April 9, 1998

Attached is a revision to the Offsite Dose Calculation Manual, LaSalle Annex, Chapters 10 through 12. Please update your manual as follows:

LaSalle Station  
Chapter 10 Change Summary  
ODCM Revision 1.9, April 1998

LaSalle Station  
Chapter 11 Change Summary  
ODCM Revision 2, April 1998

SIMPLIFIED GASEOUS RADWASTE AND  
GASEOUS EFFLUENT FLOW DIAGRAM  
(SHEET 2 OF 2)

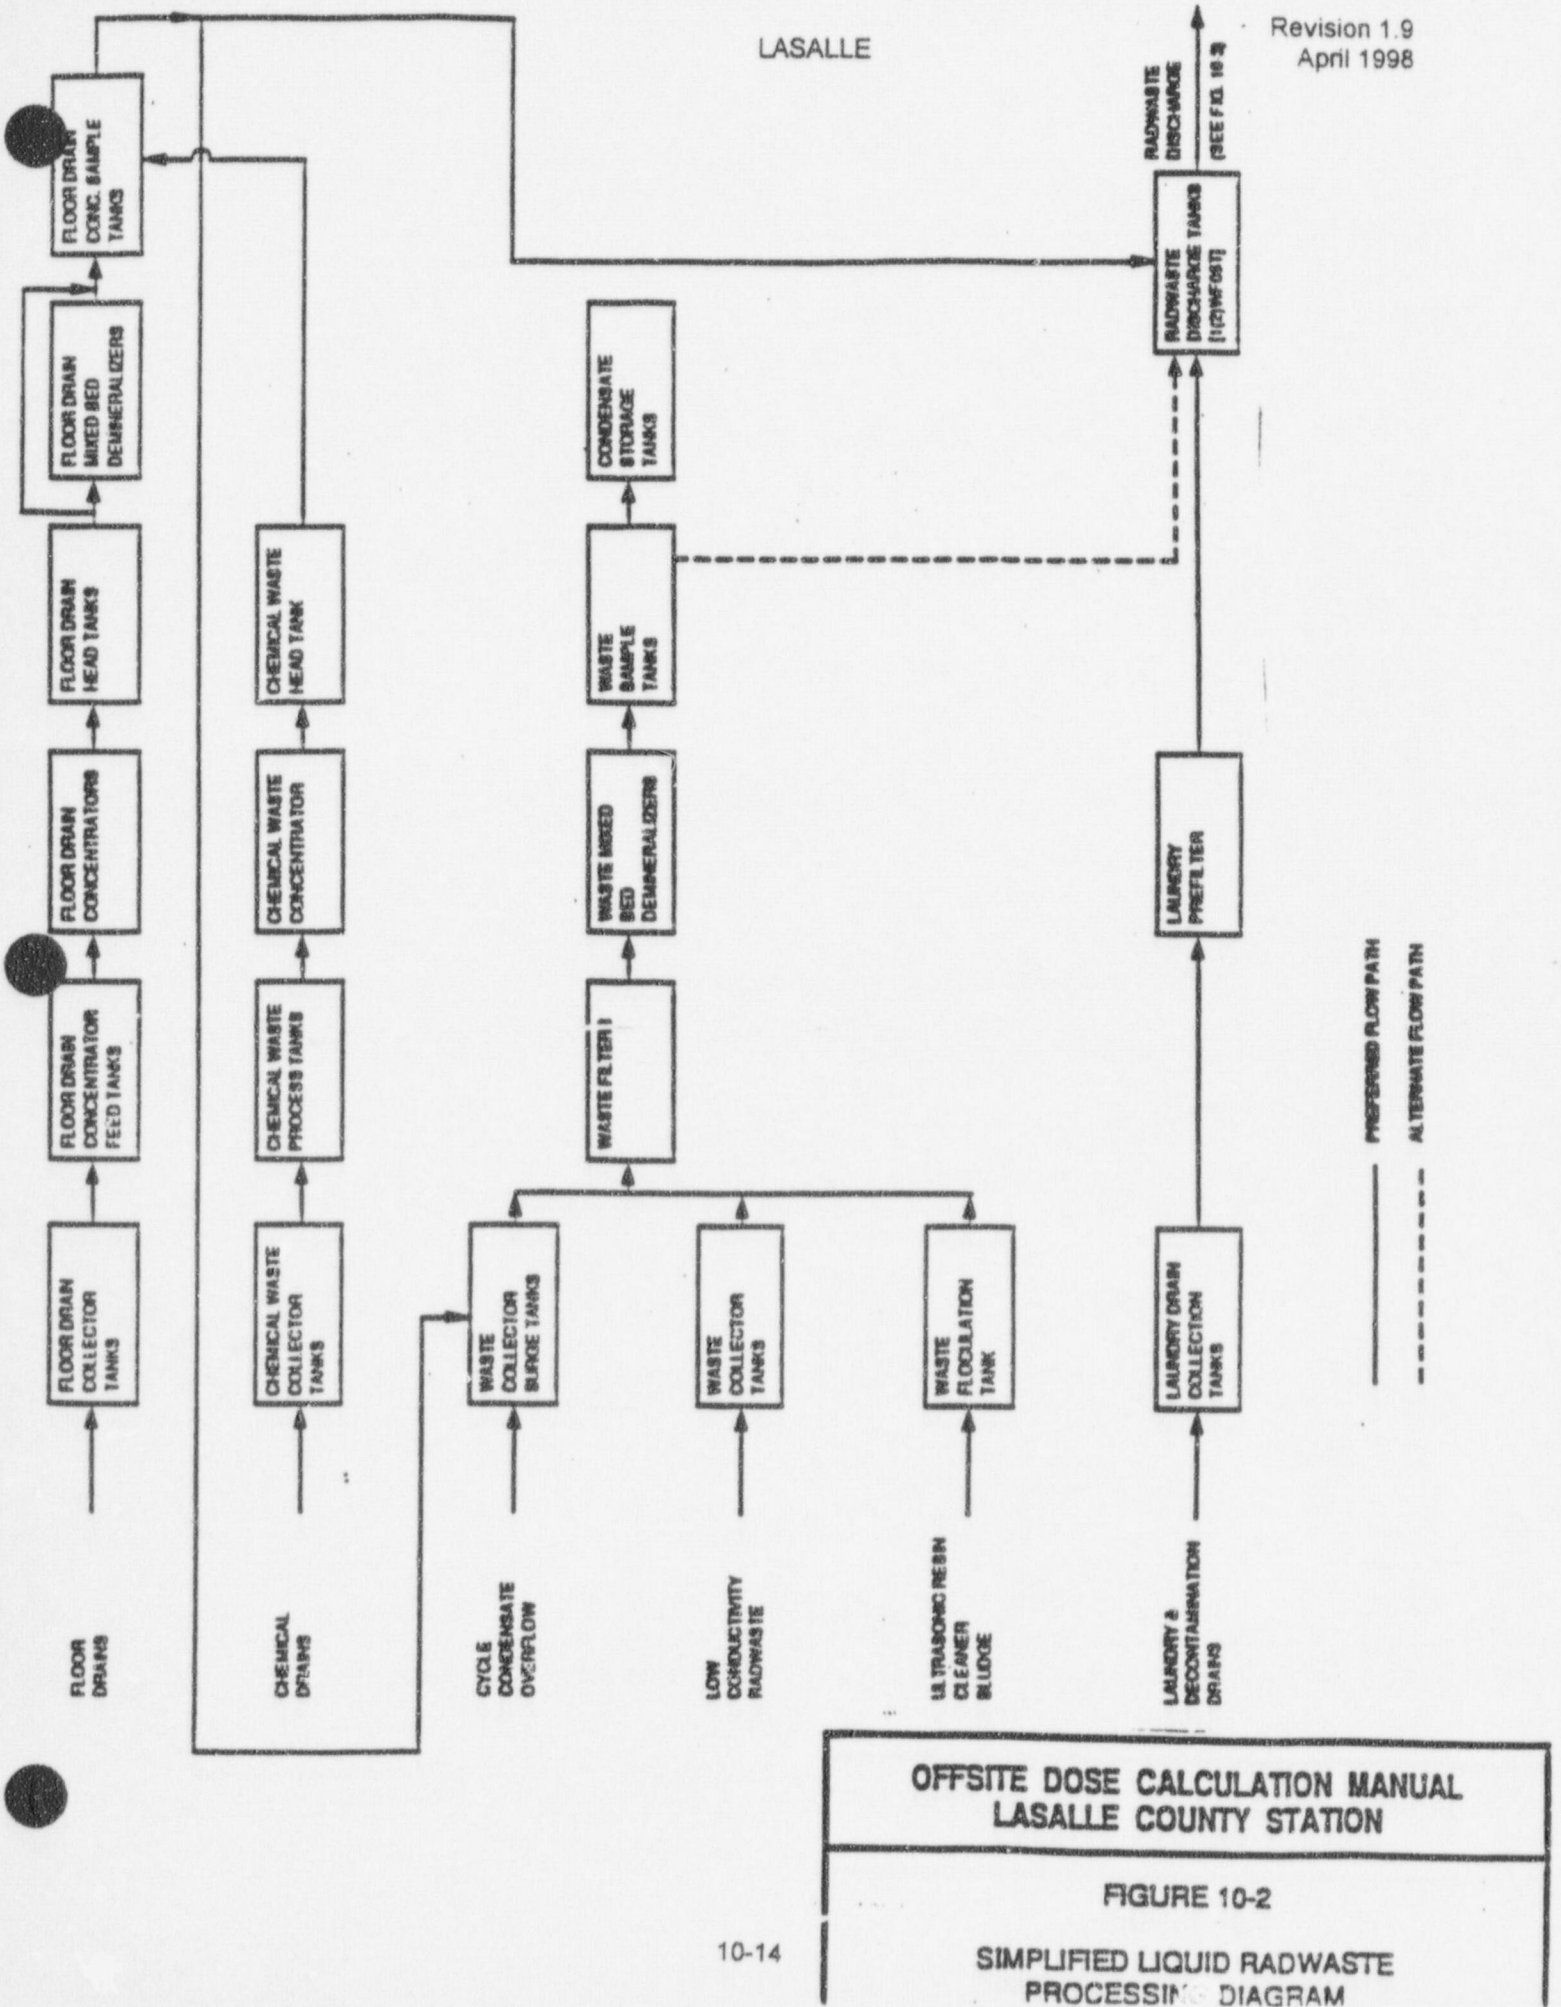
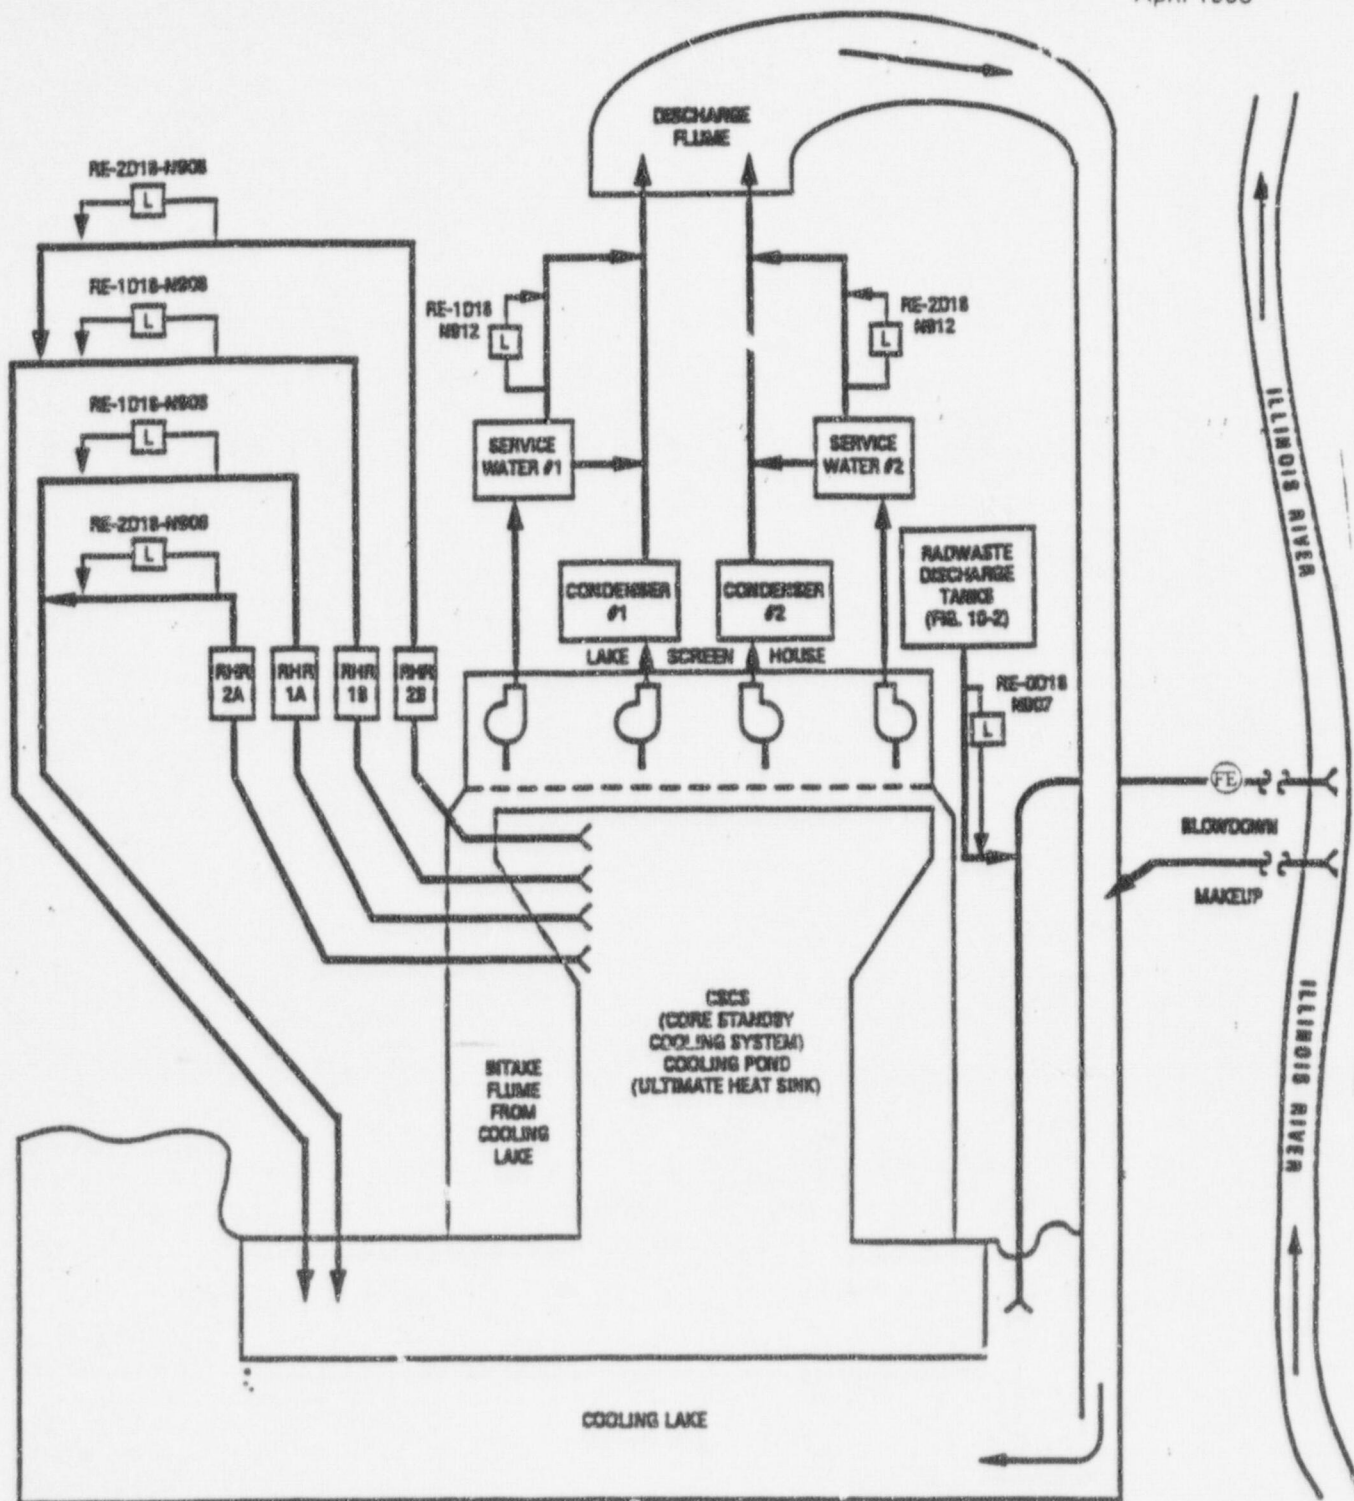
<u>Page</u>	<u>Change Description</u>
10-i	Updated revision number. Added file designator identification to bottom of page.
10-ii	Updated page numbers.
10-iii	Corrected title for Section 10.2.5 in Table of Contents to match that on p.10-12 and updated page numbers.
10-iv	Updated page number for Table 10-1.
10-v	Updated page numbers for Figures 10-1 through 10-4.
10-1	Changed date for start of oil burning to Fall of 1998.
10-4	Revised the wording for Section 10.1.3.1.2 to reflect the method for establishing setpoints for the condenser air ejector monitors.
10-7	Corrected typographical error of monitor EPN.
10-10	Revised the wording for Section 10.2.4 to clarify the allocation of liquid releases from the Station.
10-15	Revised Figure 10-3 to indicate a generic symbol for the flow element and deleted obsolete EPN.
